# Princeton University Safety Walk

November 12, 2015

revised 4/14/16

## Observations and Areas for Investigation

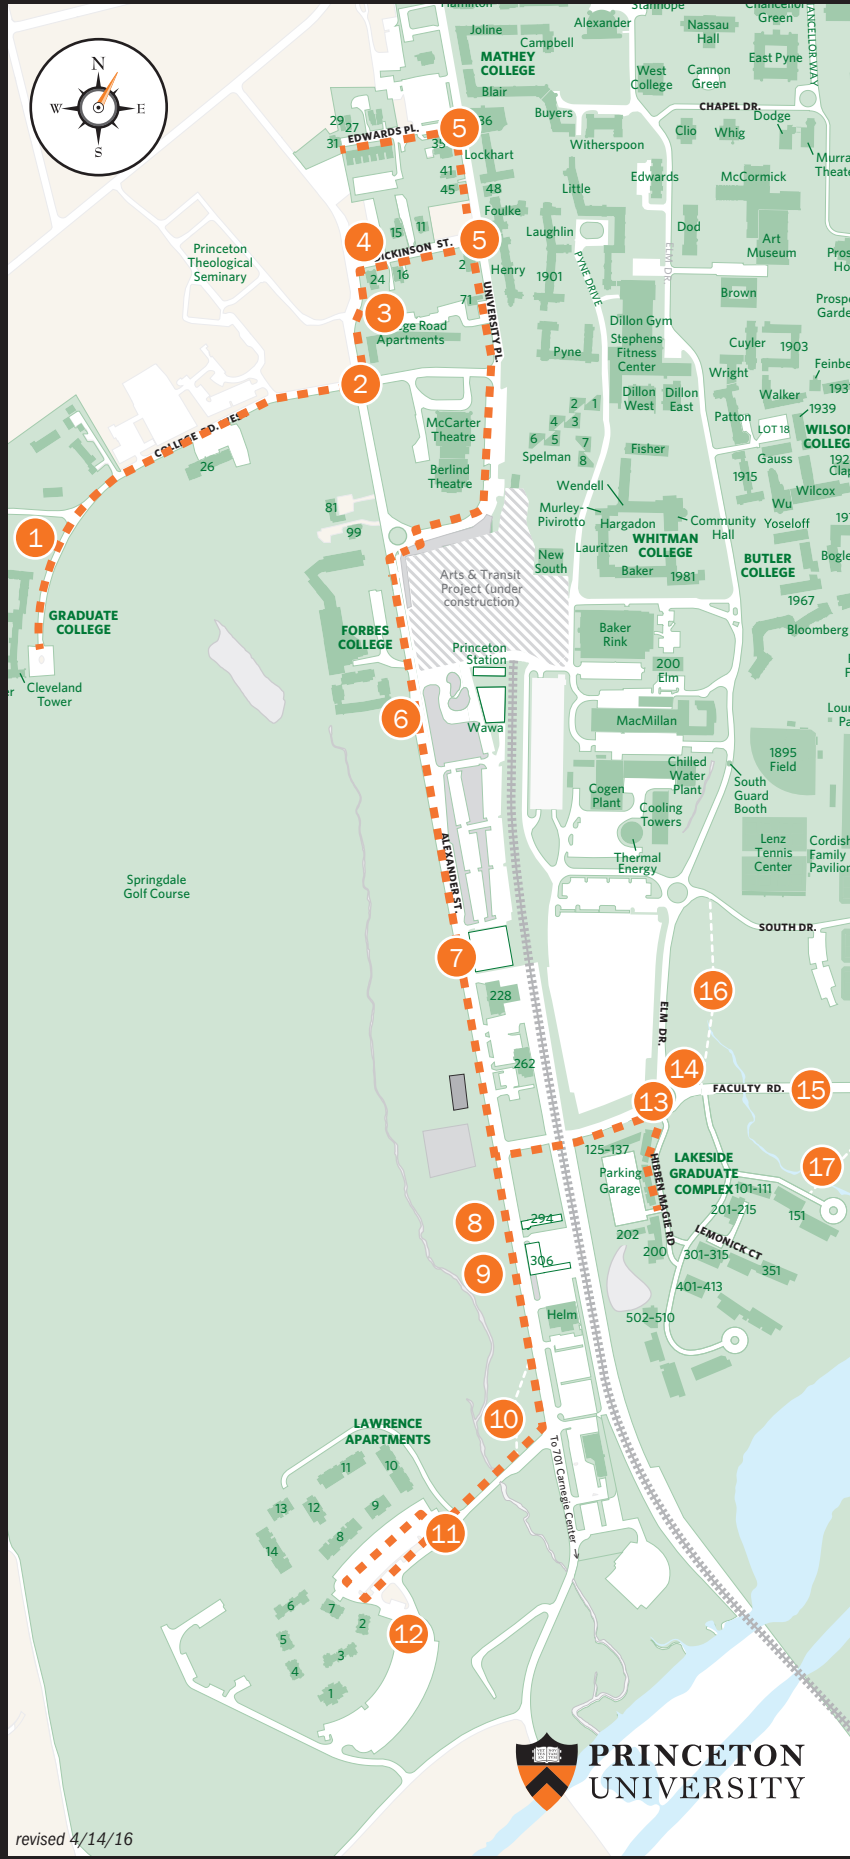
- 1 Investigate upgrading lights on path from NGC to parking lot. *Lighting upgrade completion within 6 months.*
- 2 A) Investigate replacing/moving stop sign on the west side of intersection. B) Investigate upgrading crosswalk to similar systems along Washington and Alexander Roads (mid-block crossing by Forbes). C) Investigate removing parking spot(s) on Alexander Road closest to College Road. Parked car blocks drivers' view when approaching intersection. *Traffic study underway. Changes require municipal approval.*

- 3 Investigate installation of lights on east side of Alexander Road between College Road and Dickinson Street (currently no lights). *Traffic study needed. Changes require municipal approval. Projected 2017 completion.*
- 4 Investigate possible trip hazard on sidewalk in front of 24 Dickinson Street. *Spring/summer 2016 completion.*
- 5 Investigate upgrading crosswalks on University Place at Dickinson Street and Edwards Place to similar systems along Washington and Alexander Roads. *Traffic study needed. Changes require municipal approval. Projected 2017 completion.*

- 6 Replace street light across from Wawa near Forbes College. *Spring/summer 2016 completion.*
- 7 Curb cuts for crosswalk are installed near Skillman Furniture, but no crosswalk markings on street. *Completed.*
- 8 Investigate upgrading lighting on pathway from Faculty Road to Lawrence Road. *Requires coordination with PSE&G and confirmation of funding.*
- 9 Reduce overgrowth in wooded area along pathway from Faculty Road to Lawrence Road. *Spring/summer 2016 completion.*
- 10 Investigate paving unpaved path at intersection of Alexander Road and Lawrence Road. *Violates ADA slope requirement.*

- 11 Investigate installation of sidewalk on Lawrence Road after entrance from Springdale Golf Club. Pedestrian access to Building 1 is via street. *Under review by the Office of the University Architect.*
- 12 Prune trees surrounding stop sign at Lawrence Road and Building 1 parking area. *Spring/summer 2016 completion.*

- 13 Investigate lowering shrubs on the circle at Faculty Road and Elm Drive to improve visibility of oncoming traffic. *Not recommended by University Traffic Consultant.*
- 14 Crosswalk across Elm Drive to north of Faculty Road/ Elm Drive traffic circle does not allow for reasonable reaction time by drivers approaching Elm Drive. *Traffic study underway. Changes require municipal approval.*
- 15 Investigate installation of pedestrian crossing signs at all crosswalks on Faculty Road. *Traffic study underway. Changes require municipal approval.*
- 16 Prune trees and shrubs on path through woods between Faculty Road and South Drive. *Spring/summer 2016 completion.*
- 17 Install lighting on pathway, specifically at bridge, between 151 Taylor Court and Faculty Road. *Completed.*
